# Product Change Notification

**Product Change Notification:** PCN-22-125558

PE & RE/L relay series - Change for relay sealing:

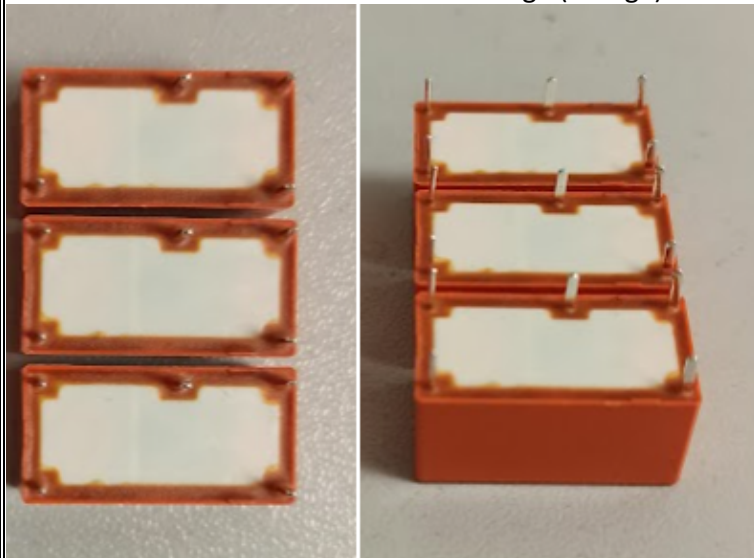
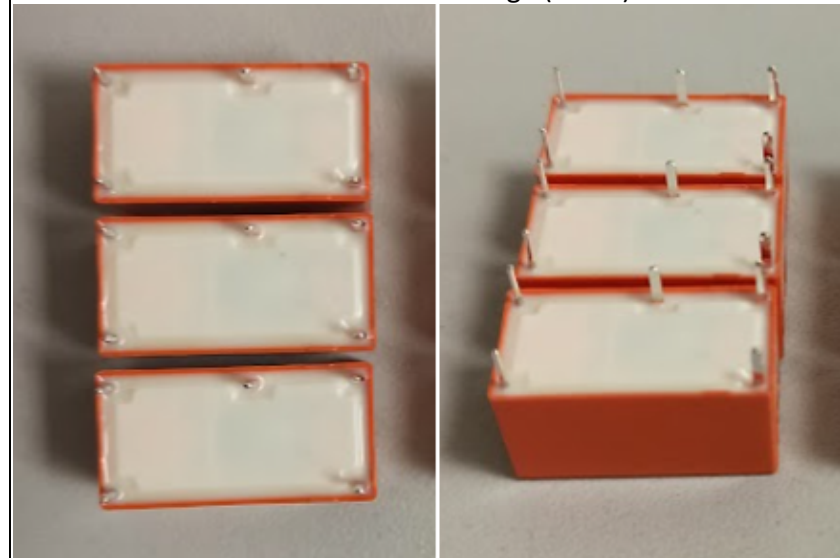
PE & RE/L relay series - Change for relay sealing: Dear customer, to keep aligned with the regulations of RoHS not just for the finished relay but also throughout the complete process of production we change the sealing adhesive. The improved adhesive appears white at the bottom of the relay. The qualification tests did not show any difference to the current adhesive (orange color).

The color of the adhesive before the change (orange)

The color of the adhesive after the change (white)
